Highgate CAAC objection to [HGY/2024/3411](#) 14 Southwood Avenue, N6 5RZ

Enlargement of cellar to create a basement level, with front lightwell, single storey ground floor rear/side extension, construction of new glazed gable at second floor level; replacement single glazed timber windows for double glazed timber windows and new rear juliette balcony at second floor.

Existing roof:

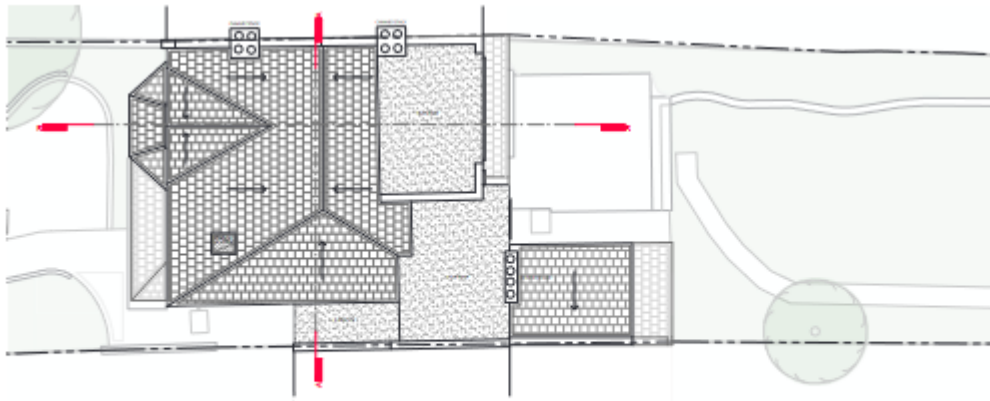
The proposed roof additions in this application are far more extensive than the precedent of [HGY/2021/2732](#), for No 16 Southwood Avenue cited in the DAS. The dormer permitted under that application was fairly limited and in keeping with policies such as DH5 of the HNP and section 12.3.13 (pp 167-8) of the Highgate Conservation Area Character Appraisal (2013).

The roof extension proposed here is clearly contrary to such policies: not subordinate in scale, and extending all the way to the back and side boundaries, even above the link section. This is also contrary to HNP policy DH5.

Proposed roof:

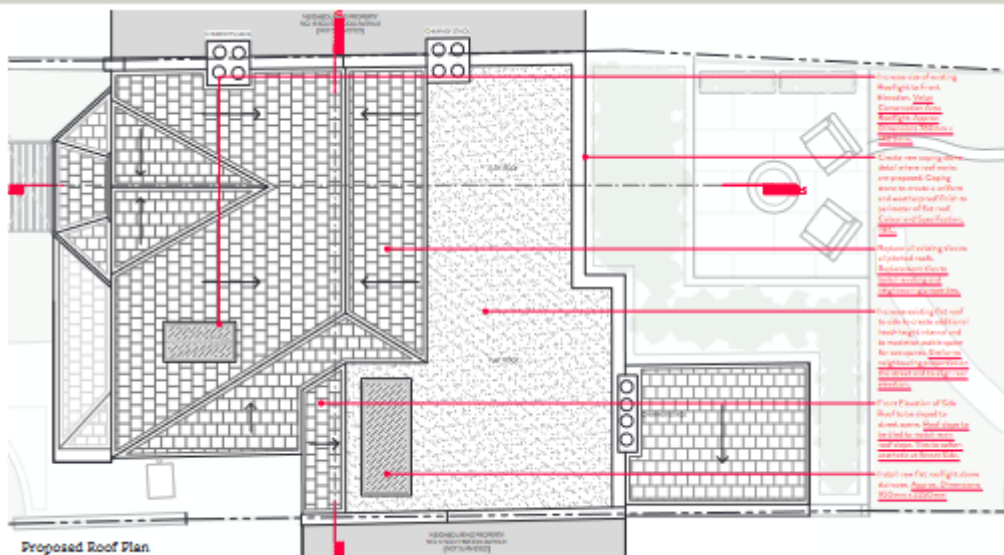
A comparison of the relevant elevation drawings makes it clear that the proposed roof extension includes a considerably higher section above the recessed link section between Nos 14 and 12 which will be clearly visible from the public domain, i.e. Southwood Lane.
